HAPA Comments on Lincoln Landing

Small improvements suggested below are consistent with project viability.

An intermodal center

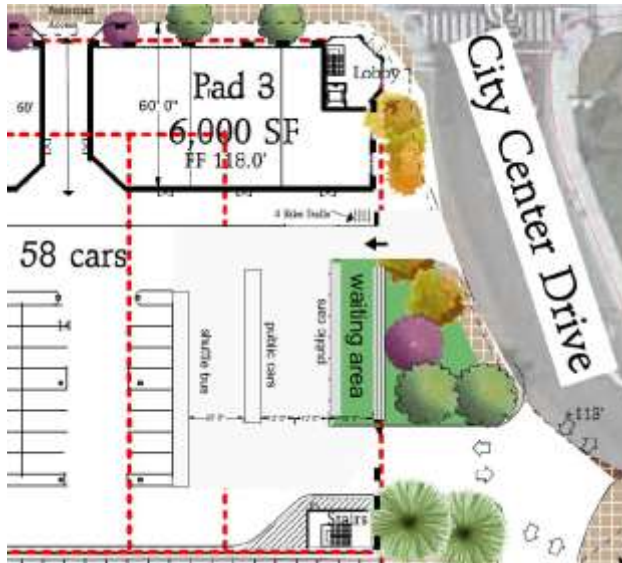
The MM should require a multi-modal center by City Center Drive, as it is a logical and convenient place for a turn-around or off-street stop for a shuttle system to BART. It is also a good place for public car pick-up and drop-off. The proposed center requires use of the parking under the City Center tower west of Store Pad 3. It needs a driveway 12 feet wide on the east side for ingress. The driveway on the west side can be used for egress. At a minimum, the ingress needs a non-bearing wall to allow for future conversion to a travel lane. The next level would be to build the facility for use by the private shuttle and public cars, which now have no location specified on the site. The public shuttle could use the facility when it is ready for implementation. The conditions need to require the developer to cooperate with a using the facility for a shuttle and related actions that may not happen with initial construction.

A concept drawing would show how the shuttle and public cars could use the area, probably requiring space now used by 16 parking spaces, out of the total of 58 spaces. There is a non-parking area of about 20 by 80 feet in green shown on the south side of the parking. It could be a waiting area with windows looking out on the lawn towards City Center Drive.
